UNITED STATES PATENT AND TRADEMARK OFFICE

Office Action Summary

10/606,350

DETAILED ACTION

Exhibit 1: Hoffman '516 Figure 2

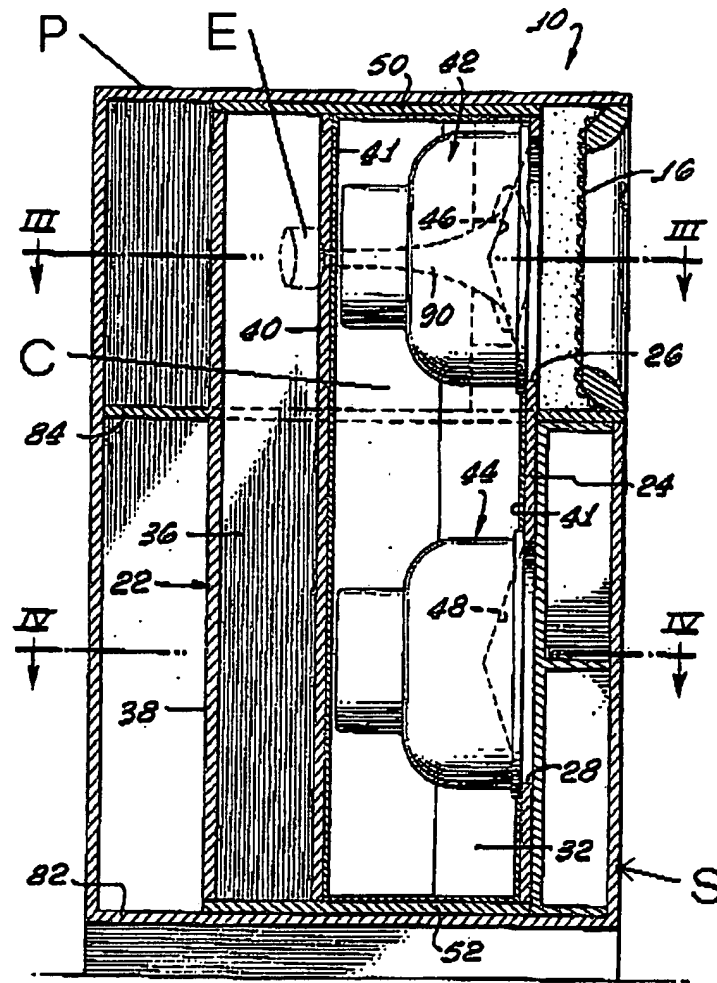
2. Claims 1-4 and 9 are rejected under 35 U.S.C. 102(b) as being anticipated by Hoffman (US Patent Number 2872516). Regarding claim 1: Hoffman (Figures 1-4) shows a speaker-provided mounting table (10) with a pedestal (uppermost surface of structure, labeled P), a hollow-shaped support member (supporting understructure, labeled S) for supporting the pedestal (P), the support member (S) also capable of functioning as an acoustic pipe and a speaker unit (44 including speaker housing and internal components) independent of the pedestal being equipped with a speaker (44) and attached to the support member (S). [Note that support member S is the supporting structure of the speaker-provided mounting table, including members 12, 14, 24, 50, 72, 80, etc. but not pedestal P.]

3. Regarding claim 2: Hoffman shows a speaker-provided mounting table (10) according to claim 1, wherein the support member (S) is configured to be capable of functioning as an acoustic pipe with an acoustic capacity (C) associated with an acoustic pipe/support member.

4. Regarding claim 3: Hoffman shows a speaker-provided mounting table (10) with a pedestal (uppermost surface of structure, labeled P), a hollow-shaped support member (supporting understructure, labeled S) for supporting the pedestal, the support member (S) also capable of functioning as an acoustic capacity, and a speaker unit (44 including speaker housing and internal components) independent of the pedestal being equipped with a speaker (44) and attached to the support member (S).

6. Regarding claim 9: Hoffman shows a mounting table (10) according to claim 3, wherein the support member (S) has an acoustic capacity (C) to cause a resonance with a vibration mass (48) of the speaker unit (44).

Hoffman '516 Figures 1, 3, and 4

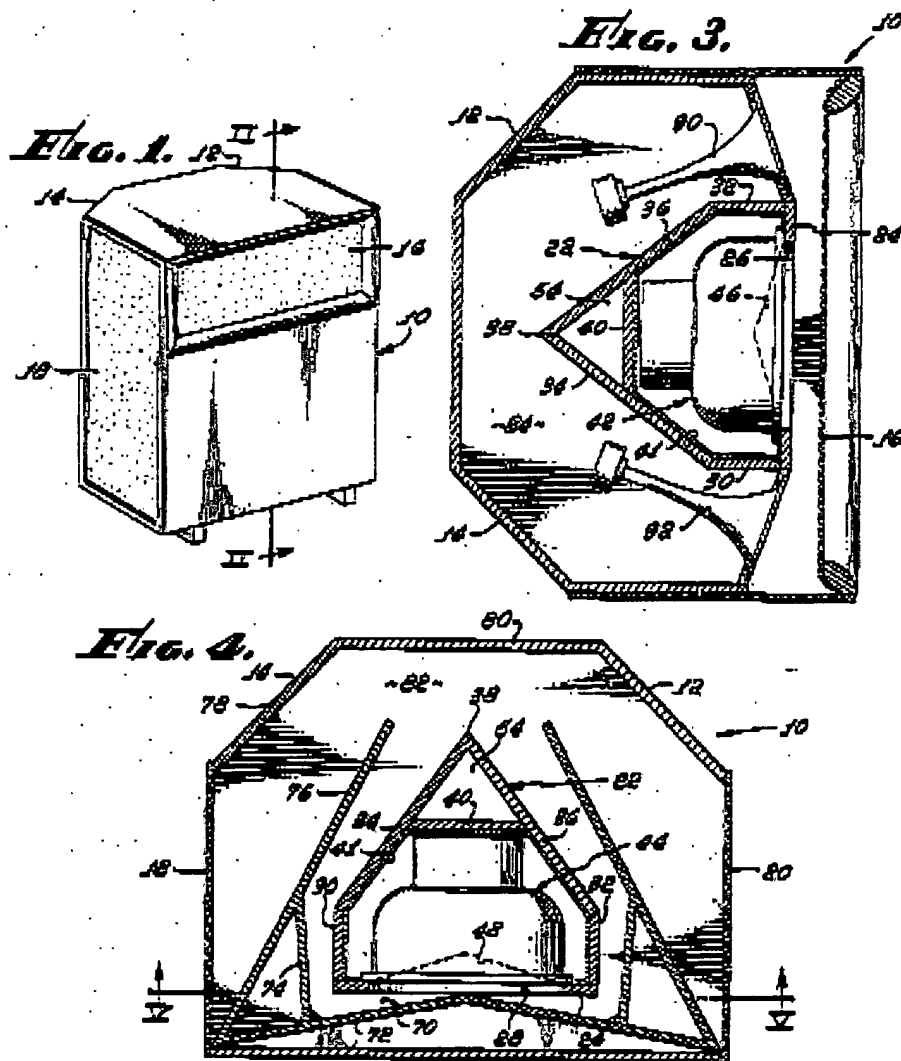
5. Regarding claim 4: Hoffman shows a mounting table (10) according to claim 1, wherein the speaker unit is composed of a dynamic electricity speaker (44). See column 3 lines 35-37.

Wilke '395 Figure 7

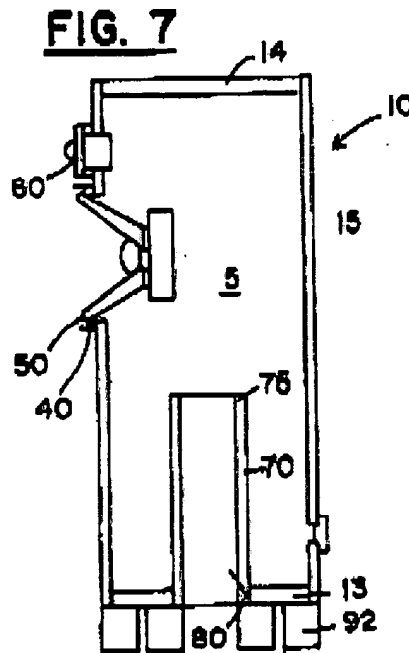
10. Regarding claim 6: Hoffman shows a mounting table according to claim 1, wherein the support member (S) is provided with an acoustic capacity cavity (cavity containing C), but lacks an aperture port for outputting the sound emitted by the acoustic capacity cavity. Wilke (Figure 7) discloses an enclosure including an aperture port (80) for outputting sound emitted by an acoustic capacity cavity (5). Accordingly, it would have been obvious to one of ordinary skill in the art at the time the invention was made to combine the aperture port of Wilke with the support member of Hoffman in order output sound emitted by the acoustic capacity cavity.

11. Regarding claim 7: Hoffman shows a mounting table according to claim 1, with a support member (S), structured such that it is capable of causing a pipe resonance therein, but lacking an aperture port for outputting sound generated by the pipe resonance. Wilke discloses an enclosure including an aperture port (80) for outputting sound generated within the enclosure. Accordingly, it would have been obvious to one of ordinary skill in the art at the time the invention was made to combine aperture port of Wilke with the support member of Hoffman in order to output sound generated by a pipe resonance.

12. Regarding claim 8: Hoffman shows a mounting table according to claim 2, wherein the support member (S) is provided with an acoustic capacity (C), but lacks an acoustic pipe and an aperture port for outputting sound. Wilke discloses an enclosure including an acoustic pipe (70), capable of allowing a resonance therein, and an aperture port (80) for outputting sound. Accordingly it would have been obvious to one of ordinary skill in the art at the time the invention was made to combine the acoustic pipe and aperture port of Wilke with the support member of Hoffman in order to create a pipe resonance and output the sound generated by the pipe resonance.

13. Regarding claim 10: Hoffman, as modified by Wilke, shows a mounting table (10) according to claim 6, wherein the support member (S) is configured to be driven by the speaker unit (44) so that the support member (S) has a function of any one of a Helmholtz resonance, a pipe resonance, or a resonance being caused on both of the speaker and the acoustic capacity (C). [Note that with a port as taught by Wilke, a

Helmholtz resonance is possible with the air (being compressible) in the support member acting as a spring and the air at the port acting as a mass.]

14. Regarding claims 11-13: Hoffman discloses a table as recited in claim 9, and, when modified by Wilke as described above, discloses a table as recited in claim 6. Wilke further discloses a support member (10) formed to have a frequency to cause a (pipe or Helmholtz) resonance, the frequency being set to replay a lower-band sound (see for example column 5 lines 11-12). [Again, note that with a port as taught by Wilke, a Helmholtz resonance is possible with the air (being compressible) in the support member acting as a spring and the air at the port acting as a mass.]
